Index Sheet
Tyler St. Hole Ave.
Kidd St. Purdy St.
for zoning case R-25-789

PROJECT NO. 78-46
R-2308
SHEET 1 OF 3
HORIZ. SCALE: 1" =
VERT. SCALE: 1" =
FILE NO. 126.2

Street Plan and Profile
Kidd St. - Tyler St. to 450' e'ly
Tyler St. - Hole Ave. to 200' n'ly
for zoning case R-25-78

INDEXED BY BLD
ACCOUNT NO. 78-46
R-2308
SHEET 3 OF 3
File No. 126.2

DRIVEWAY APPROACH DETAIL
HOLE AVE.
SCALE 1" = 20'

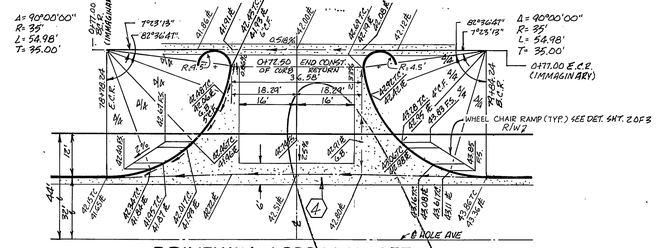
7. CONST. 2"x4" REDWOOD HEADER.
8. CONST. CURB & GUTTER PER C/R STD. DWG. 200 TYPE I 6" C.F.
9. ⚠ CONST DRIVEWAY APPROACH PER C/R STD. DWG. 302 ~~A=38' B=24'~~ A & B AS SHOWN.

REVISED TEMPORARY ACCESS TO KIDD ST. - NO SCALE

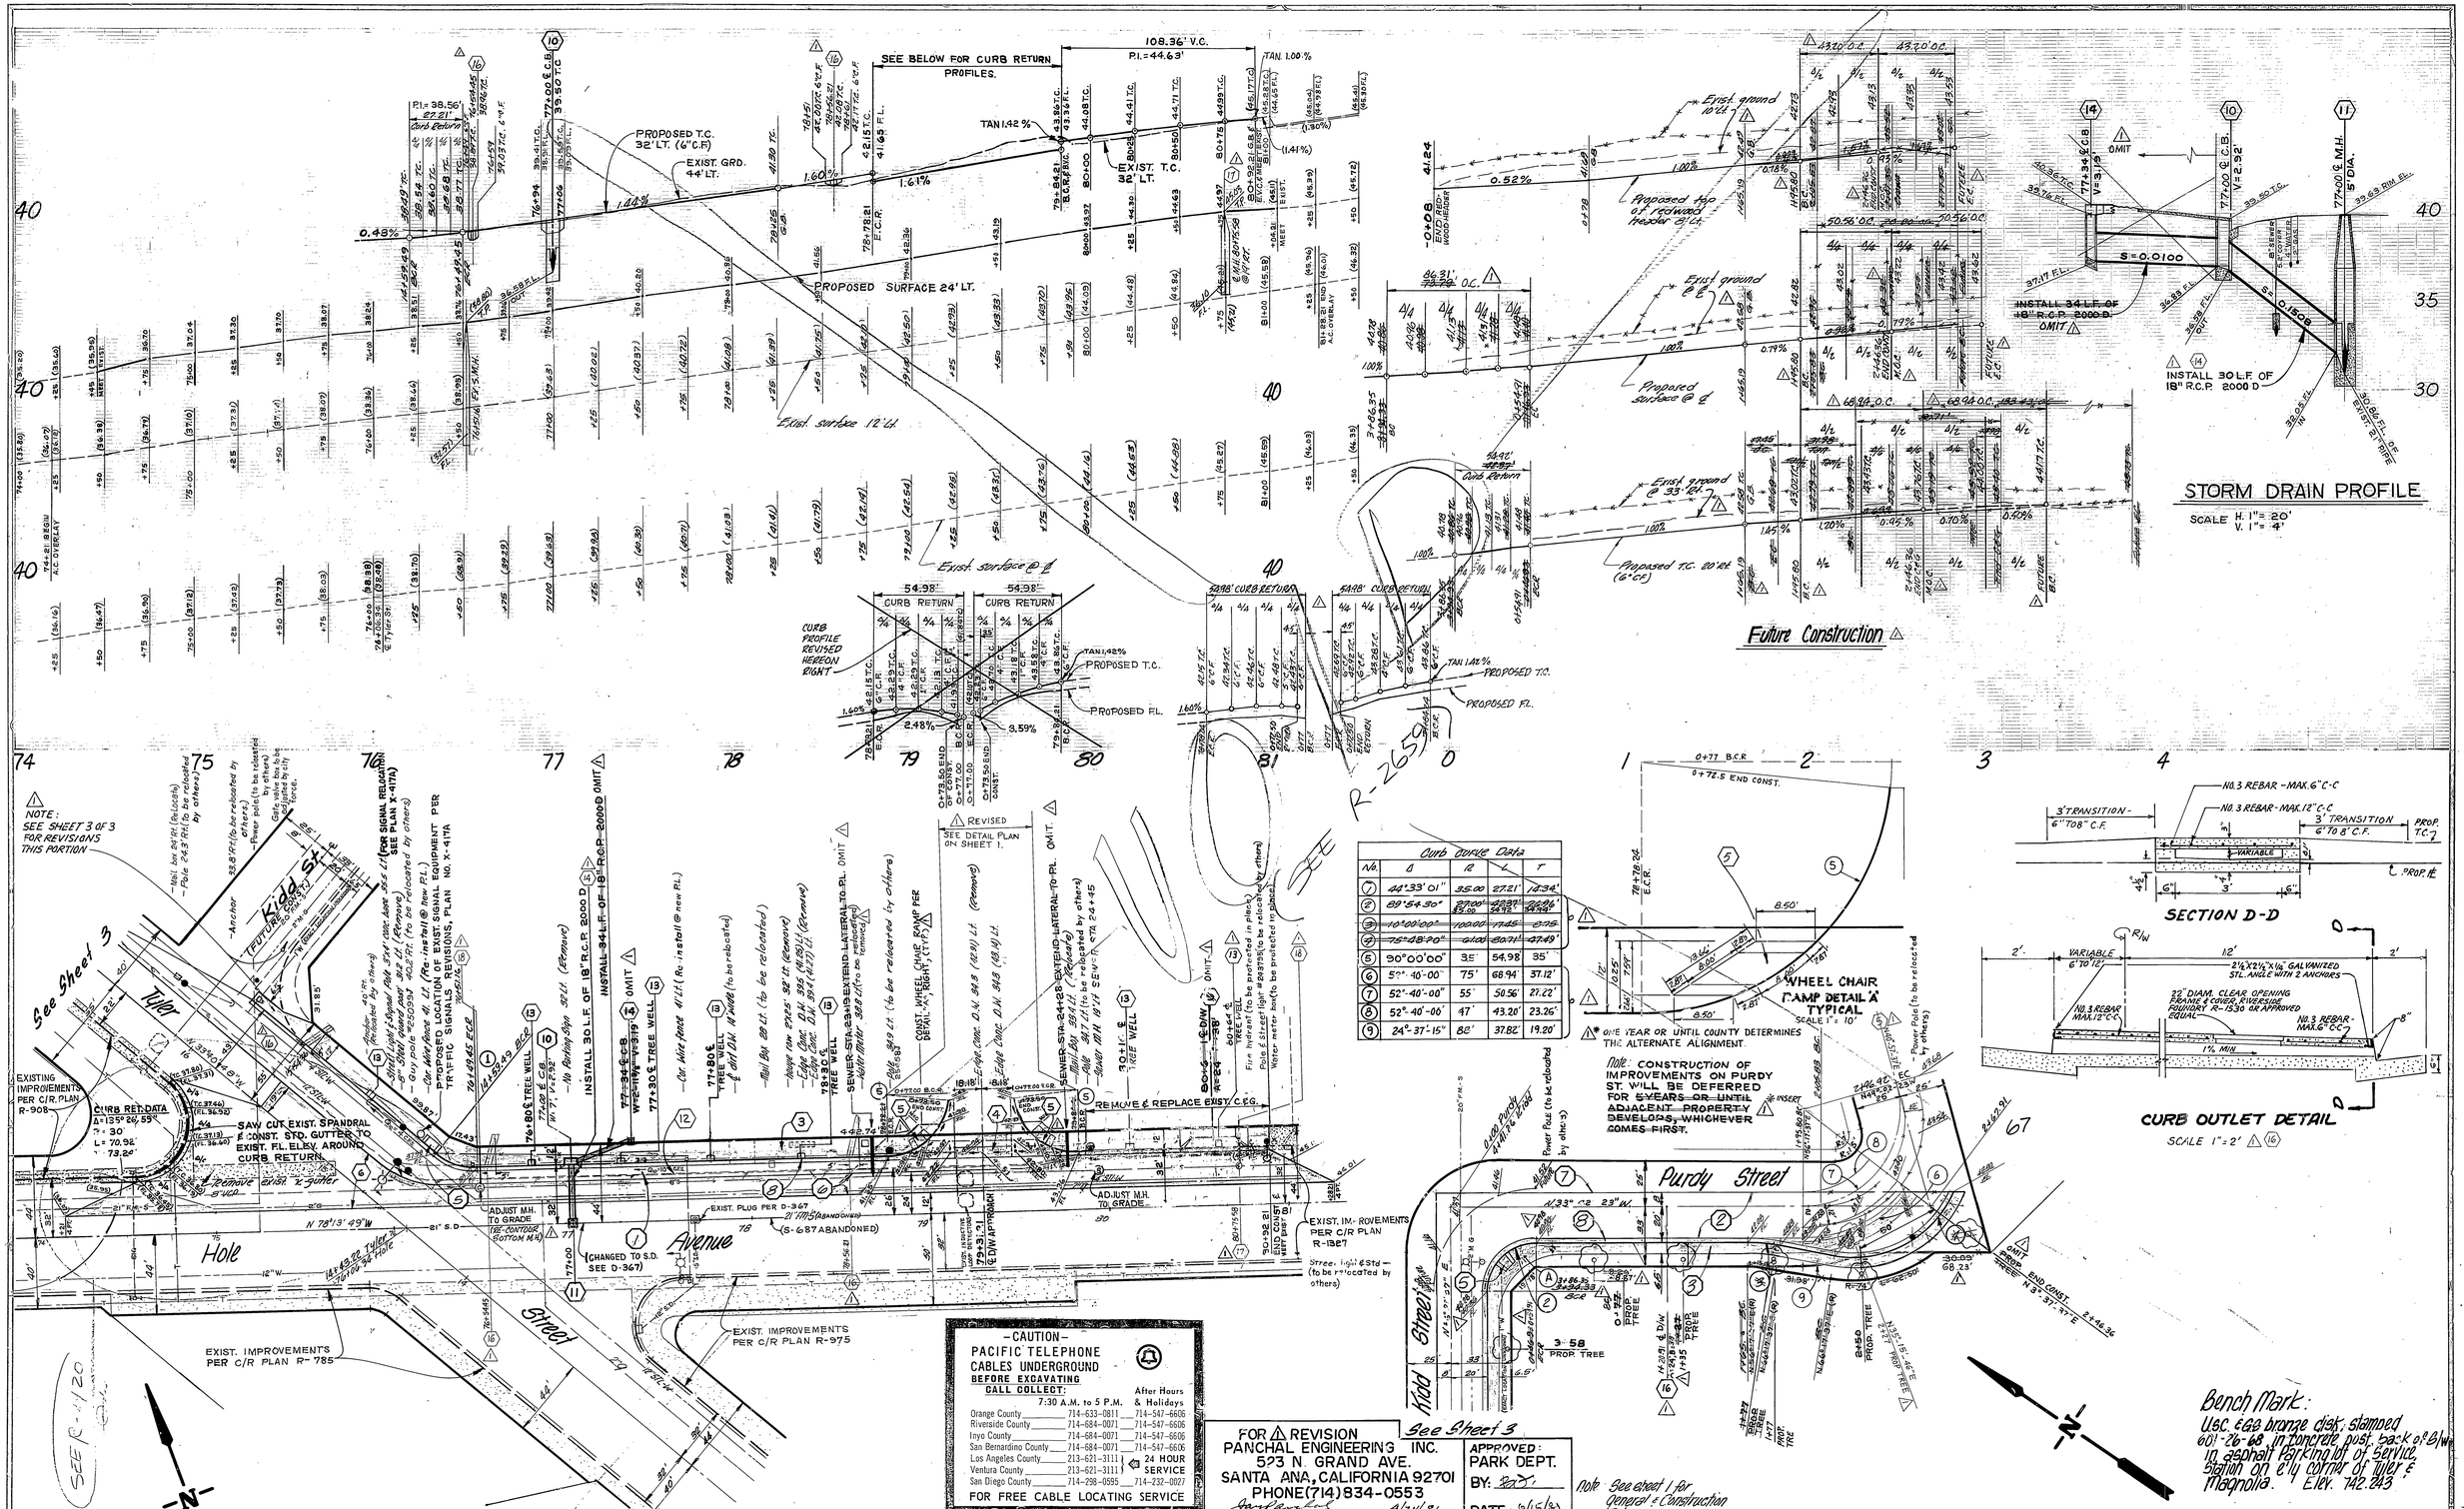
CONST. TEMPORARY 2½" THICK A.C. SWALE IN LIEU OF FUTURE X-GUTTER

Note: CONSTRUCTION OF IMPROVEMENTS ON KIDD ST. WILL BE DEFERRED FOR ~~5 YEARS OR UNTIL ADJACENT PROPERTY DEVELOPS, WHICHEVER COMES FIRST~~ ONE YEAR OR UNTIL RIVERSIDE COUNTY DETERMINES THE ALTERNATE ALIGNMENT, WHICHEVER COMES FIRST. △

MARK	REVISIONS	APPR	DATE
△	ADDED REVISED 'PLAN' DETAIL FOR TEMP. TRAFFIC DIVING TO KIDD ST., DELETED 'PLAN' APPROACHES, REVISED CURB RETURN RADIUS (KIDD ST. - TYLER ST.)	RLV	6-12-81
